Model	DJF for F401 / F411 / F421 / Lily	Volt/Hz	Date of Modification	Serial Number
Modified Article	Screw			
Reason for Modification	To prevent screws from becoming loose

Model: DJF for F401 / 411 / 421 / Lily		Date: 15-Mar-97	No: 002	1/2
Modified Article: Feed-out Drive Roller Holder			Prepared by: F. Noguchi	
From: QAC 1st Field Information Dept.			Checked by: T. Inoue <i>T. Inoue</i>	
Reason for Modification:	☐ Parts catalog correction	☐ Vendor change	☐ To meet standards	
	☐ To facilitate assembly	☒ To improve reliability	()	
	☐ Part Standardization	☐ Other

Feed-out Driven Roller Holder

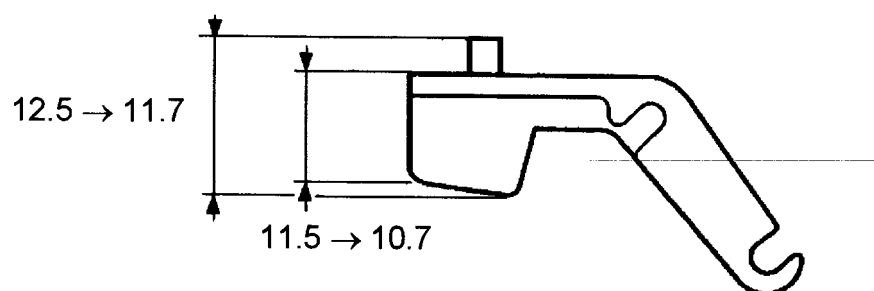
It was found in the factory test that thick DLT duplex originals (90K) sometimes jammed due to accumulated paper dust on the inverter roller. To correct this, the strength of the feed-out roller spring has been changed from 3.9N to 4.7N.

To increase the gap between the feed-out driven roller holder and the lower cover, the shape of the feed-out driven roller holder has been changed

Old part number	New part number	Description	Qty	Int	Page	Index	Note
A376 3611	A610 3157	Feed-out Roller Spring	4 - 4	O/O	15	33	
A610 3155	A610 3156	Feed-out Driven Roller Holder	4 - 4	O/O	15	21

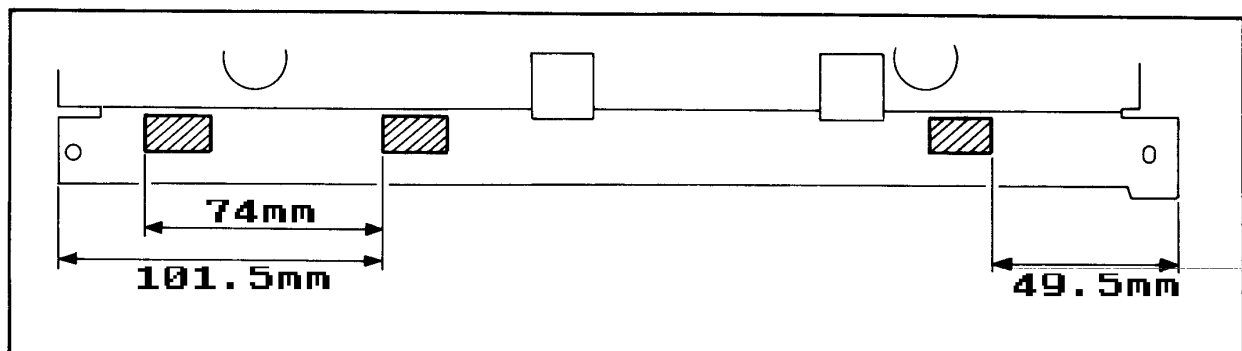
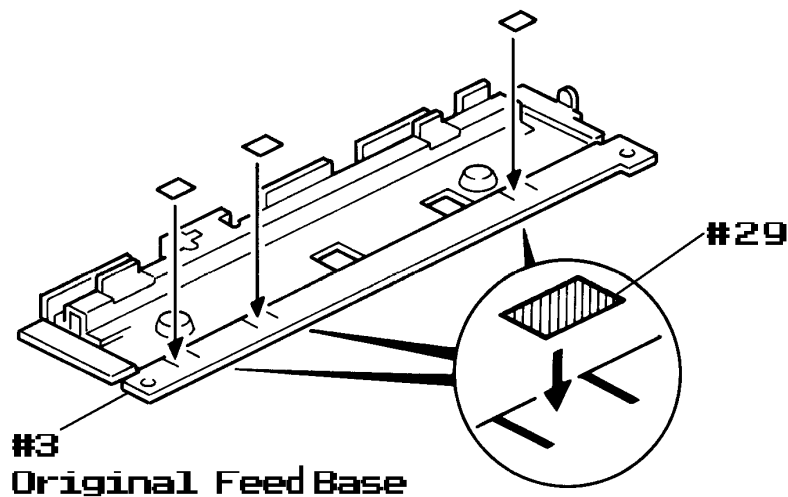
To prevent detection errors, sensor seals (black) have been attached to the original feed base.

New part number	Description	Qty	Page	Index	Note
A610 1245	Sensor Seal	0 - 3	11	29	New Index

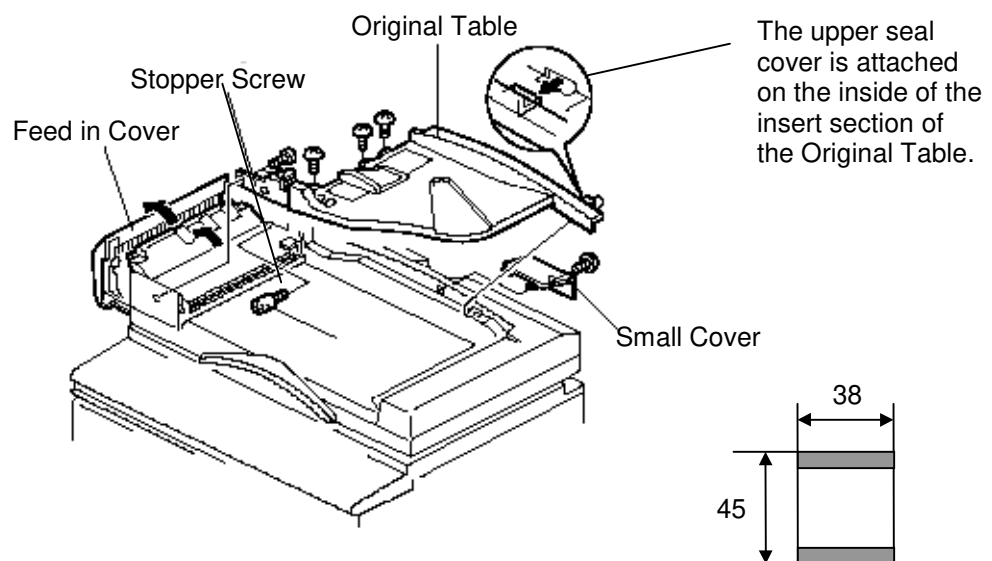
Foreign material (staples, etc.) may enter through the DF and drop down onto the main board and cause it to short-circuit. To prevent the introduction of foreign material, the upper cover seal has been added.

Old part number	New part number	Description	Qty	Int	Page	Index	Note
	A6104525	Upper Cover Seal	1		5	28

Page 13

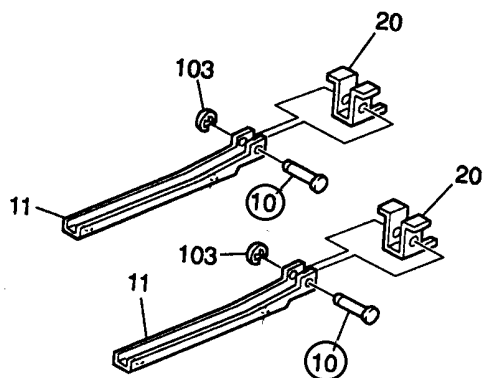
To facilitate assembly, E-rings will be placed on only one end of the following shafts.

Old part number	New part number	Description	Qty	Int	Page	Index	Note
A6102213	A6102220	Hinge Shaft	2	O/O	13	10	
07200030B		Retaining Ring-M3	n-n-2	---	13	103	
A6104113	A6104117	Left Stay Shaft	1	O/O	17	21	
A6104114	A6104118	Right Stay Shaft	1	O/O	17	25	
07200030B		Retaining Ring-M3	n-n-2	---	17	113

Page 6

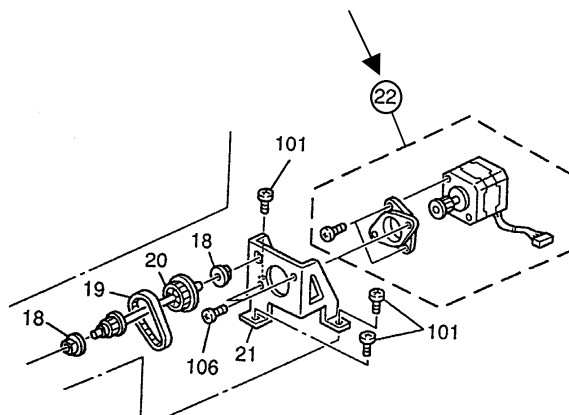
Due to parts standardization, the following parts have been changed.

22: A6101530→A6101531

Page 10

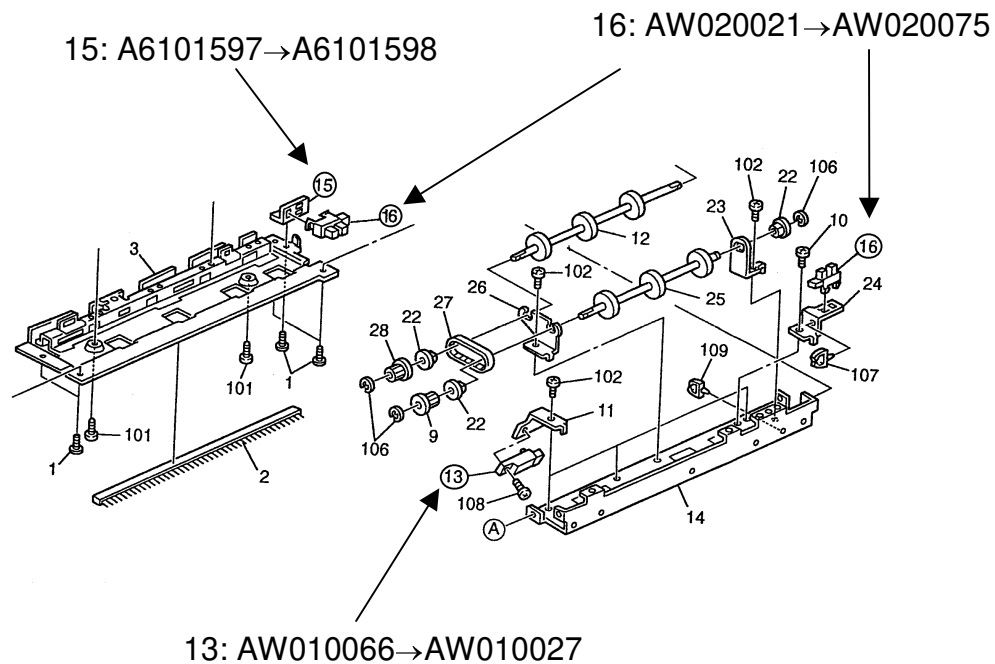
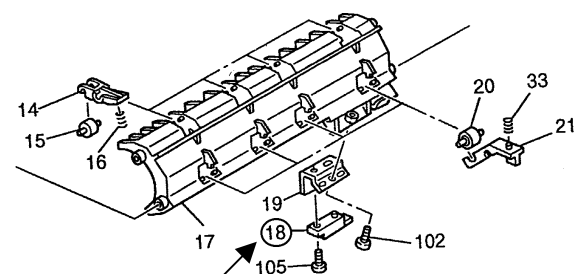
* When replacing with the new photointerrupter (16), be sure to use the new sensor bracket (15).

Old part number	New part number	Description	Qty	Int	Page	Index	Note
A6101530	A6101531	Separation Belt Drive Motor	1	O/O	7	22	
AW010066	AW010027	Photosensor- PS-R50D1-B	2	O/O	9	22	
		Photosensor ON2530CT	3	O/O	11	13	
			1	O/O	15	18	
AW020021	AW020075	Photointerrupter-175487	2	O/O	9	25	
			1	X/X	11	16	*
		Photointerrupter	1	O/O	11	16	
			2	O/O	17	36	
A6101597	A6101598	Sensor Bracket	1	X/X	11	15	*
AX060082	AX060160	Belt Drive Motor-DC19W	1	O/O	15	28	
11070752	11070884	Fuse-5A 250V	1	O/O	17	112

Page 8

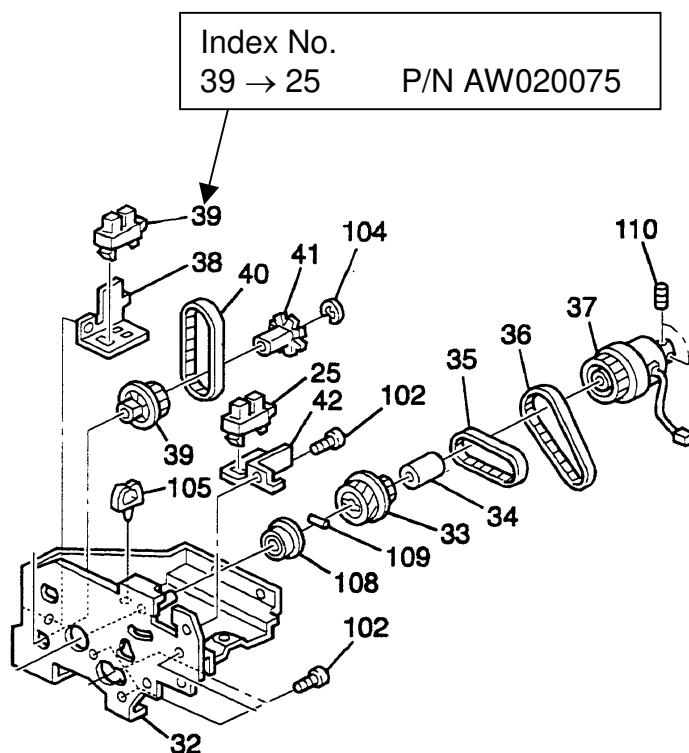
Index No. Correction (in the Illustration)
Please correct your parts catalog as follows:
